**CULTURAL RESOURCES OFFICE
PRESERVATION BOARD
REGULAR MEETING
MONDAY JUNE 24, 2013 — 4:00 P.M.
1520 MARKET ST. #2000
www.stlouis-mo.gov/cultural-resources**

DATE: June 24, 2013
ADDRESS: 2856 Salena Street
ITEM: Preliminary Review to install new front door and entryway.
JURISDICTION: Benton Park Certified Local Historic District — Ward 9
STAFF: Bob Bettis, Cultural Resources Office

DATE: June 24, 2013
ADDRESS: 2720-22 South Jefferson Avenue
ITEM: Preliminary Review to install 10 windows on the front façade in response to the denial of recent application to retain non-compliant windows.
JURISDICTION: Benton Park Certified Local Historic District — Ward 9
STAFF: Bob Bettis, Cultural Resources Office

2856 SALENA ST.

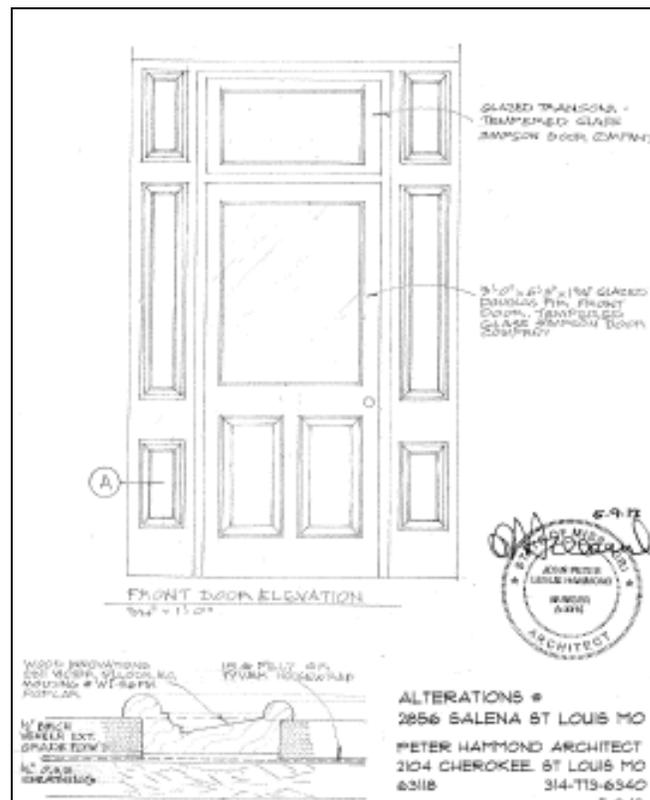
Does not comply as the proposed entry does not replicate the original condition or a Model Example. The original entry consisted of two angled doors as shown by evidence on the interior and given the width of the exterior opening. At some point the entry was modified to incorporate a single centered door that does not meet the current district standards. The proposed alteration is for a single door with flanking side panels. The proposed door, which has already been purchased, does not match the original panel configurations which are still extant on the reveals of the recessed entry.

- 2856 Salena is located in the Benton Park Local Historic District.
- The entry’s original configuration had two angled doors.
- The entry of the building was reconfigured from paired doors to a single door yet some of the original design remains on the sides of the entrance.
- The proposed entryway is not based on an acceptable Model Example. The applicant has submitted examples of paired entries that are wider and have doors that are parallel to the façade as opposed to being placed in an angled position.
- The purchased door does not match the configuration of the existing historic paneling, as was the historic condition.

Based on the preliminary findings, the Cultural Resources Office recommends that the Preservation Board deny the Preliminary Application to replace the entry as it does not comply with the Benton Park Historic District Standards. The Office recommends that the applicant use a Model Example with two angled doors to recreate the historic condition or install a new door and surround that replicates the paneling and proportions of the existing historic material in the entrance.
